The purpose of this letter is to respond to your April 11, 2016 notification of the Design Review Approval for the 1169 Sesame Drive proposal.

We are appealing this decision and look forward to hearing this issue before the City Planning Commission. Please find enclosed our appeal fee of \$161.00.

The purpose of this letter is to provide an addendum to our April 26, 2016 letter appealing the the Design Review Approval for 1169 Sesame Drive.

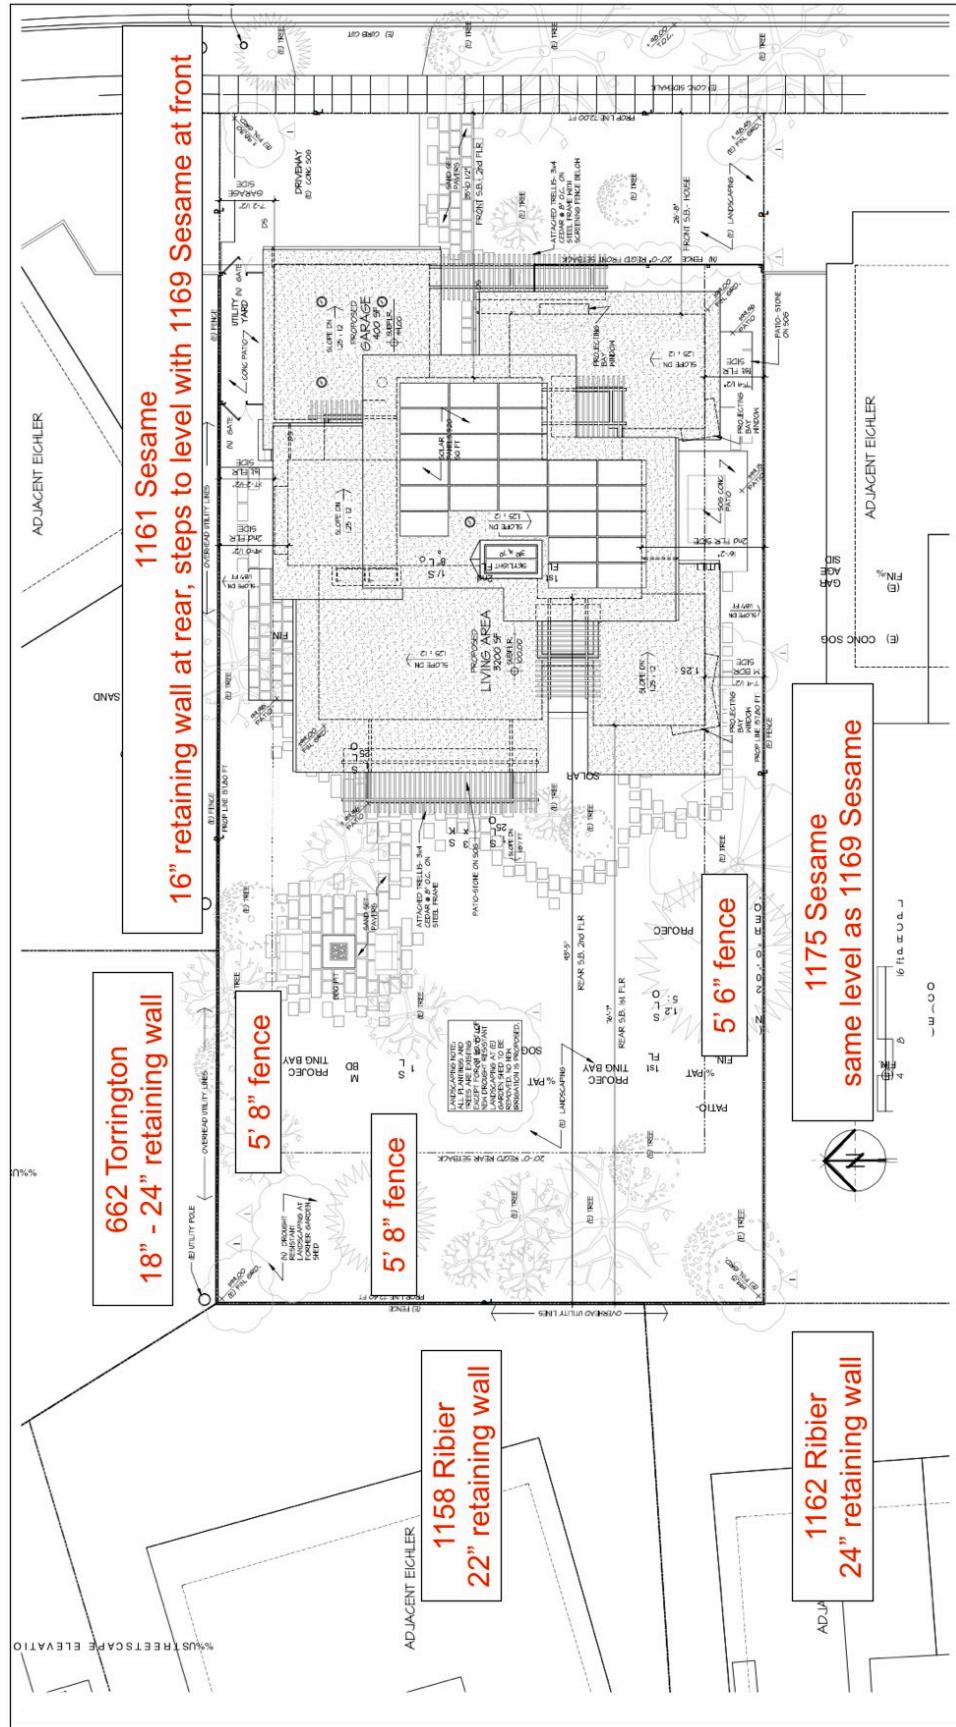
The Eichler homes located at 662 Torrington Drive, 1158 Ribier Court, and 1162 Ribier Court share rear fence lines with 1169 Sesame Drive.

It is important to note that there is a relative difference in the lot height of these properties when considering sight lines and privacy concerns.

1169 Sesame - Site plan (provided by Alk E.)

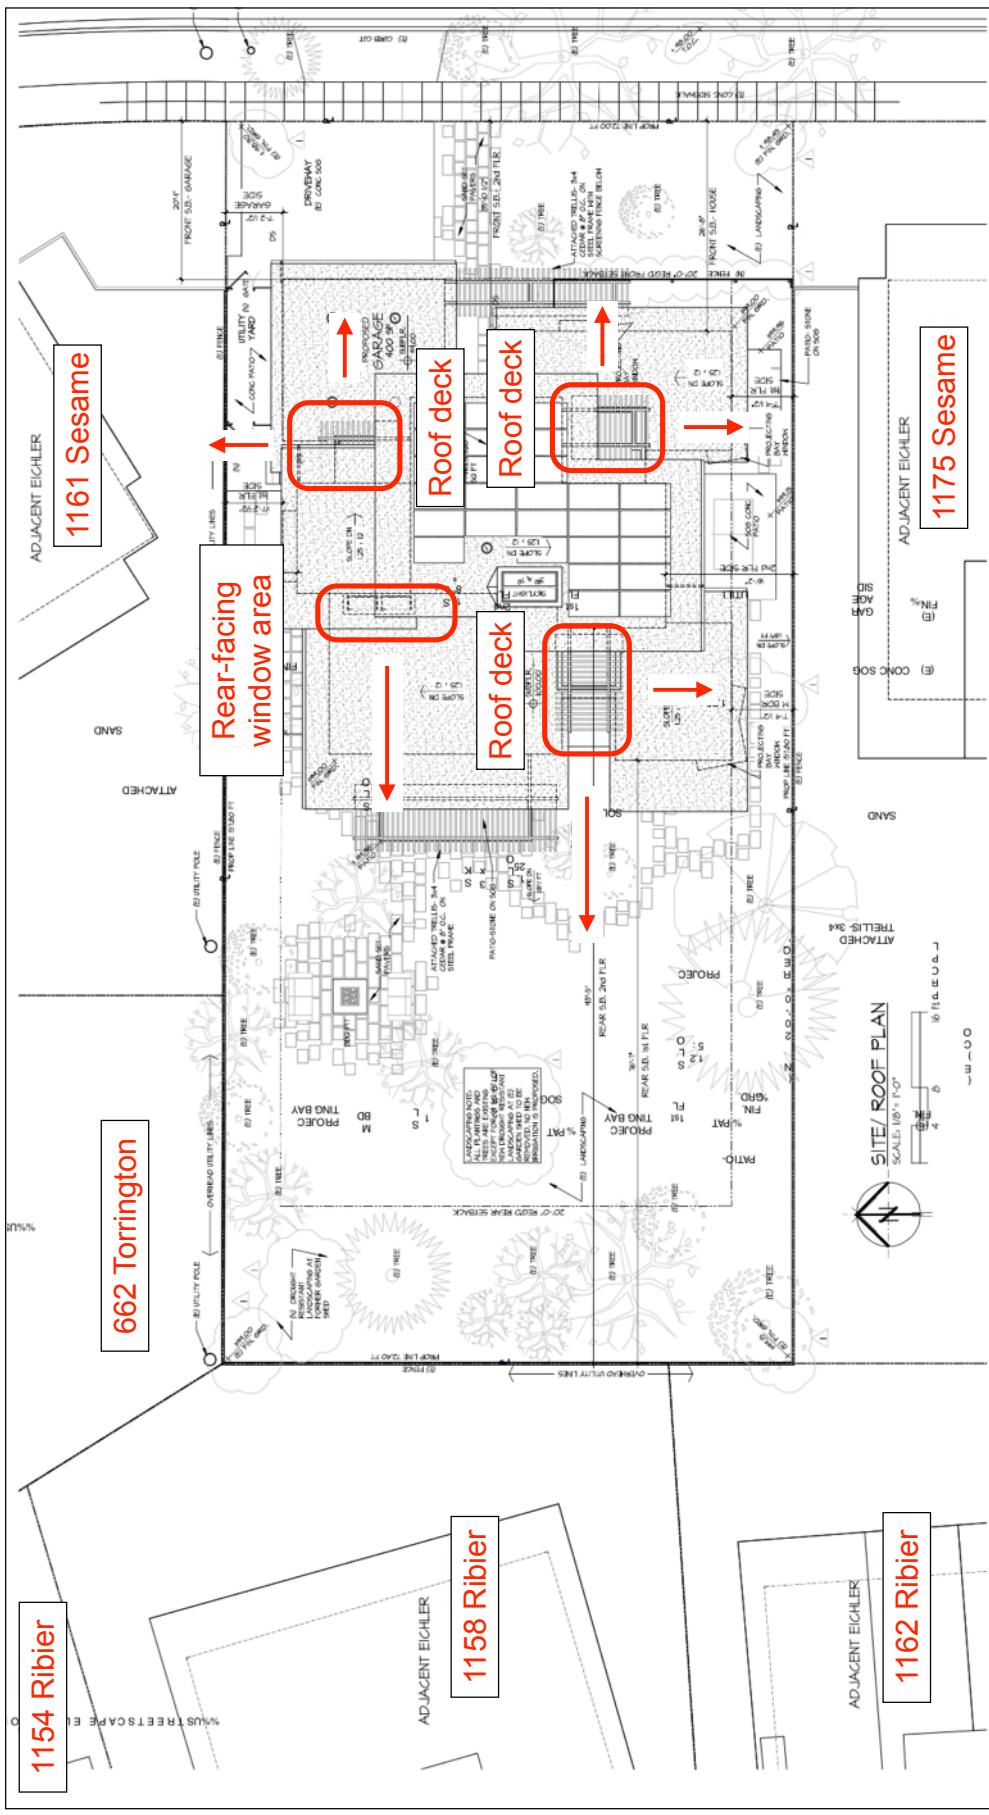
The proposed design of the 1169 Sesame house includes 3 roof decks and a number of rear-facing windows. The rear roof deck provides views of four neighboring homes to the west and south. The two front roof decks provide views of the neighboring homes to the north and south. All of the adjacent neighbors are affected by these features.

The proposed 1169 Sesame house includes 3 roof decks and rear-facing windows that affect all of the adjacent neighbors, 5 homes in total.

662 Torrington Drive - Perspective sketch of rear yard and private living spaces

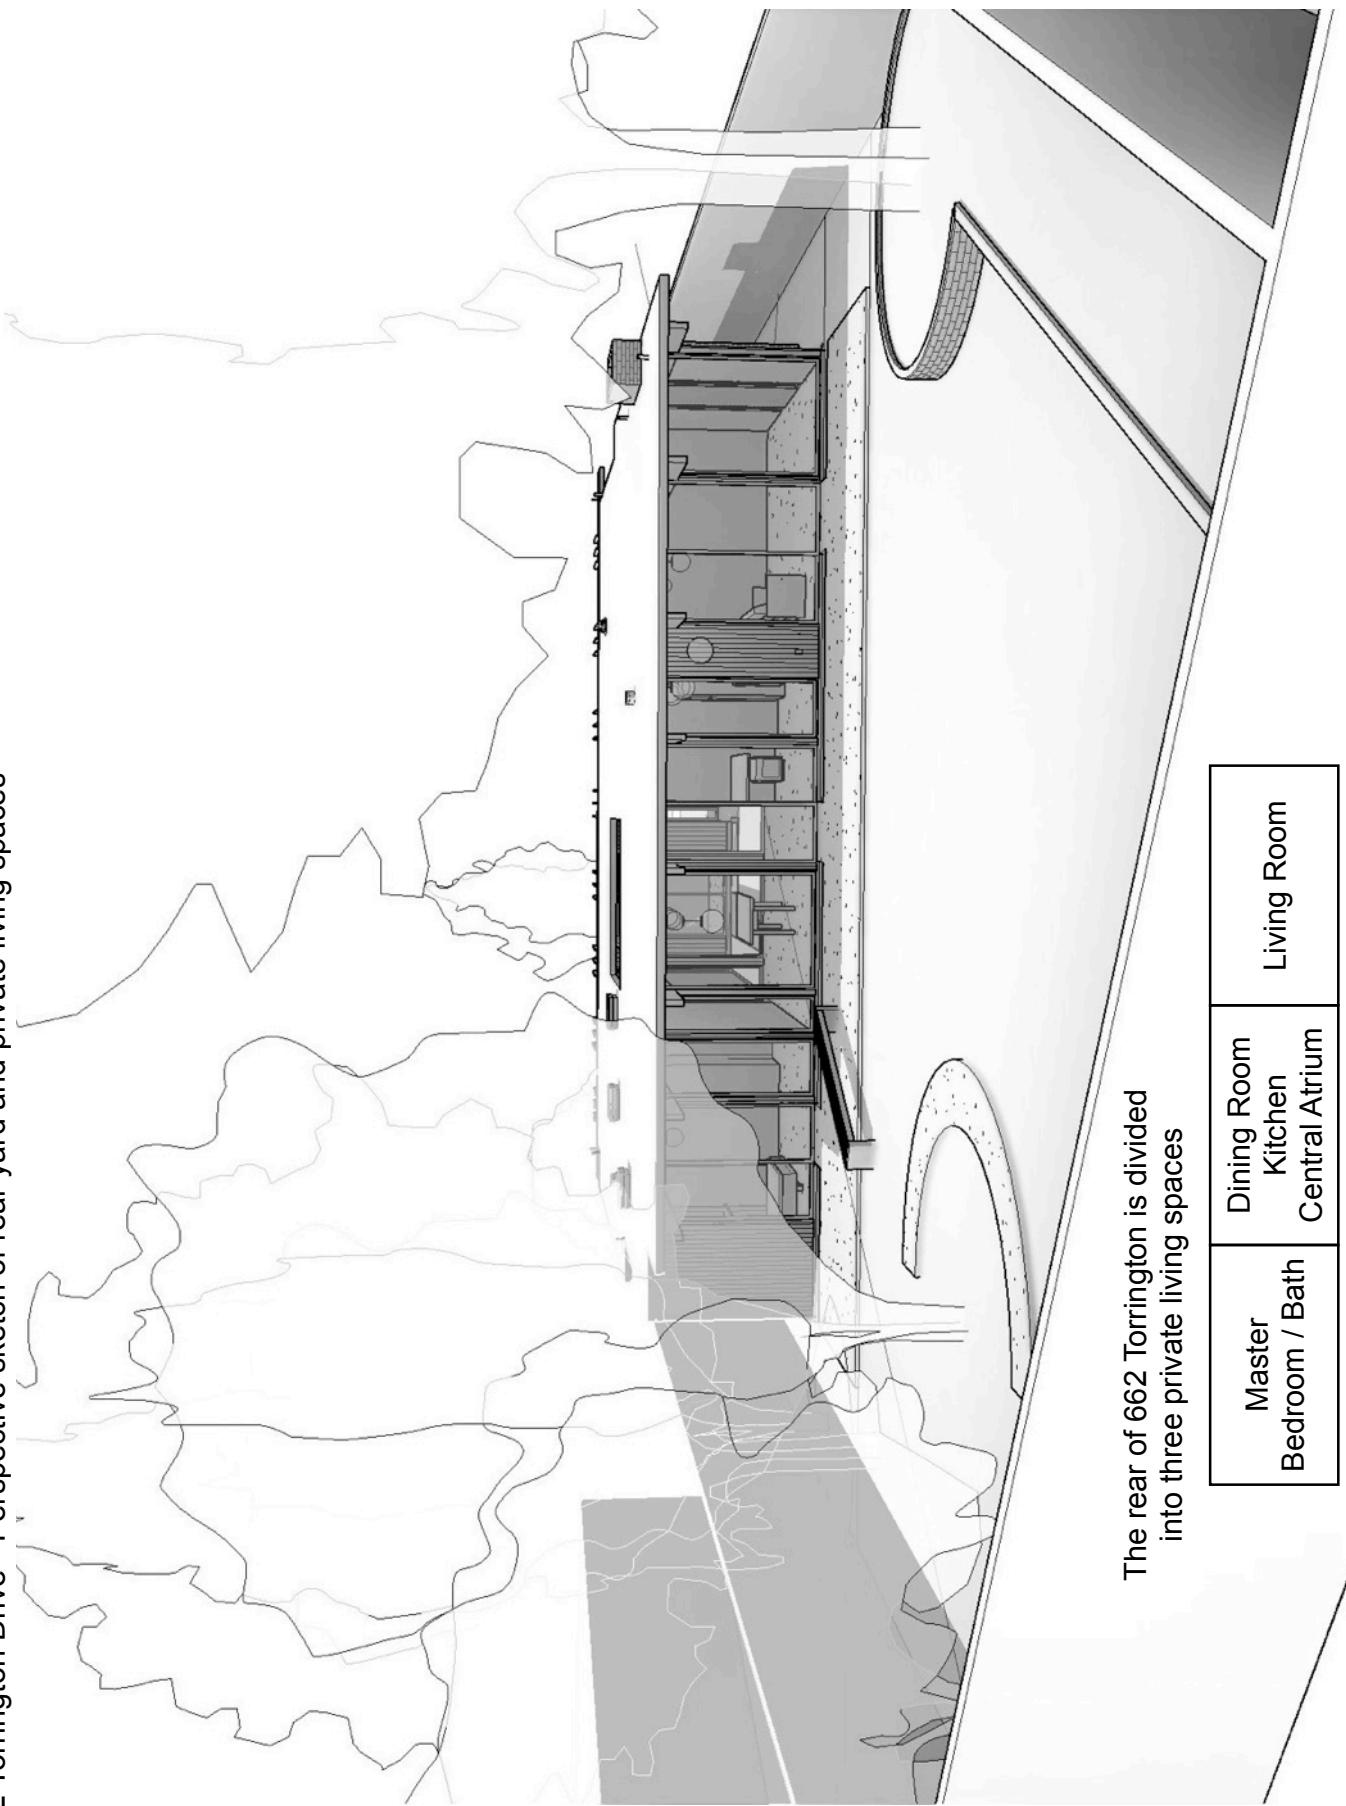
Please refer to pages 3 and 4 of the attached drawings, which show the rear facing view of 662 Torrington and illustrate the views from the 1169 Sesame bedroom window and rear deck.

1169 Sesame - Perspective sketch from 662 Torrington rear yard viewpoint (provided by Alik E.)

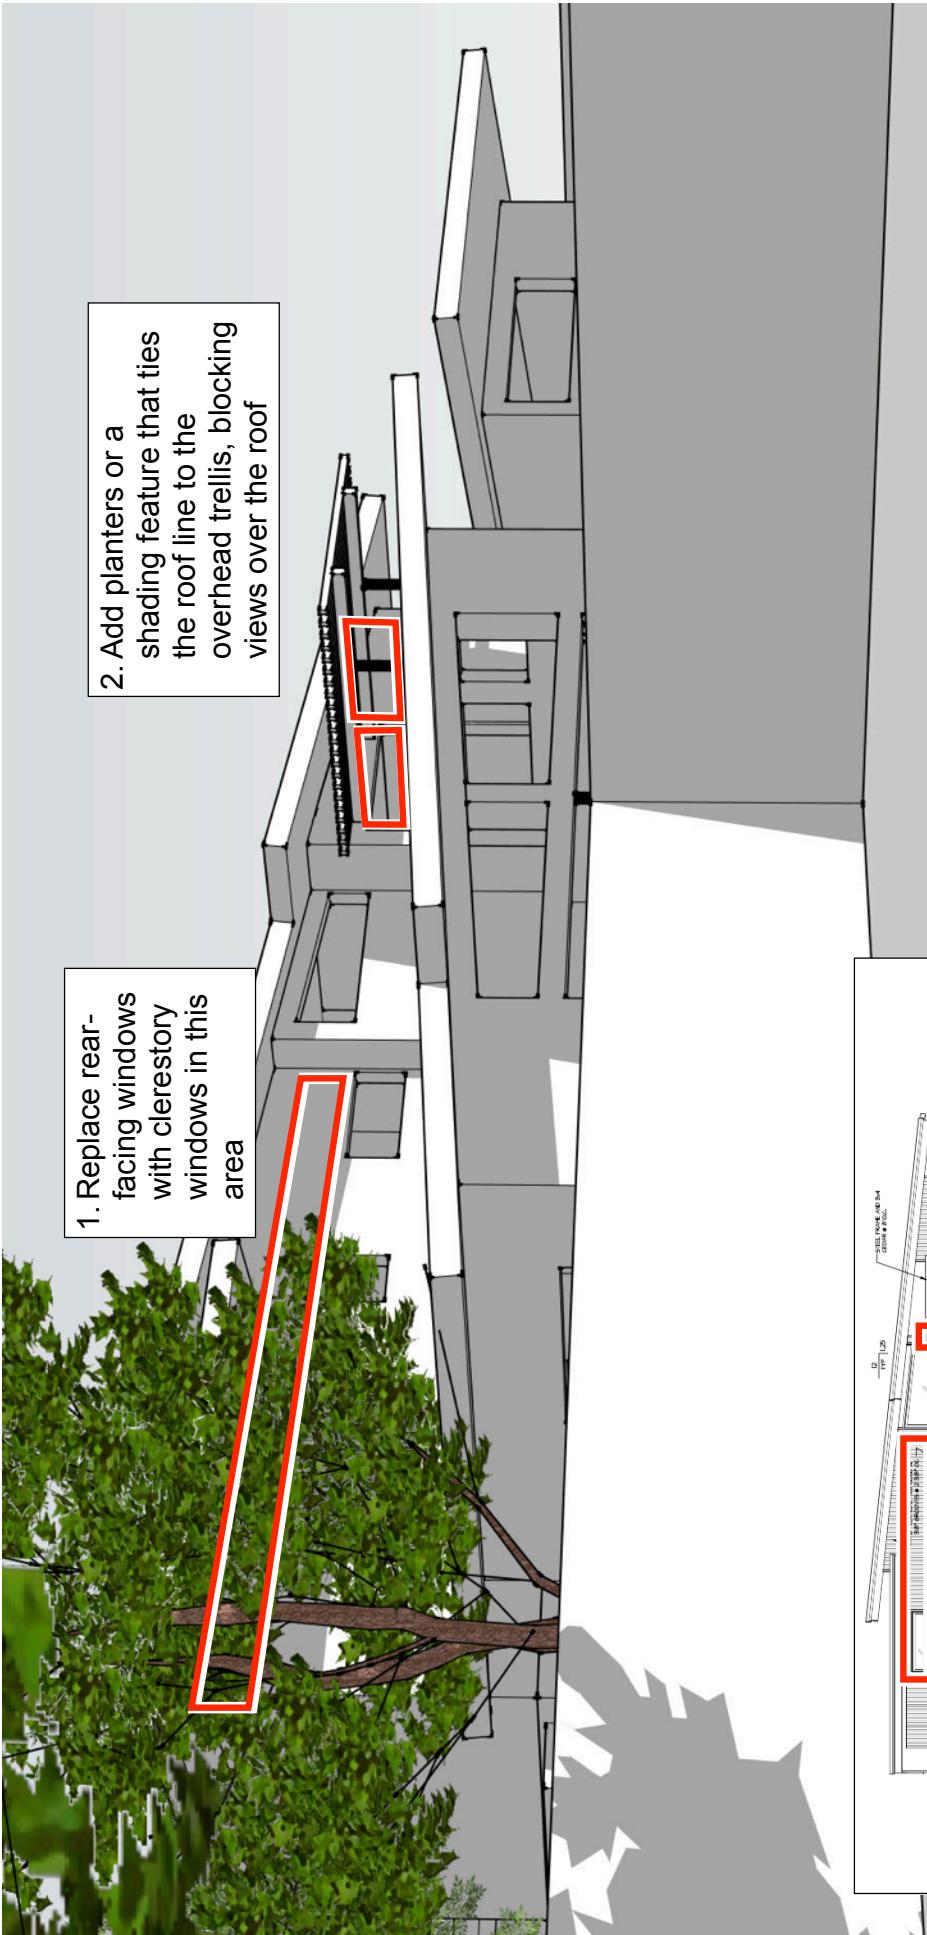
Please refer to pages 5 and 6 of the attached drawings, which show a view from the rear yard of 662 Torrington highlighting the location of the roof deck and windows, and illustrating the proposed changes.

Proposed changes to
1169 Sesame to address
662 Torrington privacy
issues

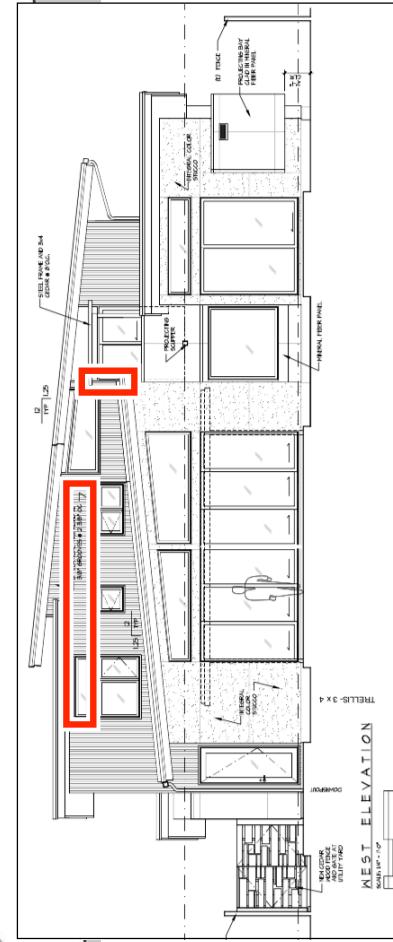
- 1. For the roof deck, add planters or a shading feature that ties the roof line to the overhead trellis, blocking views over the roof to our house.**
- 2. Replace the rear windows and bedroom window with clerestory windows that do not provide direct views into our house or yard.**
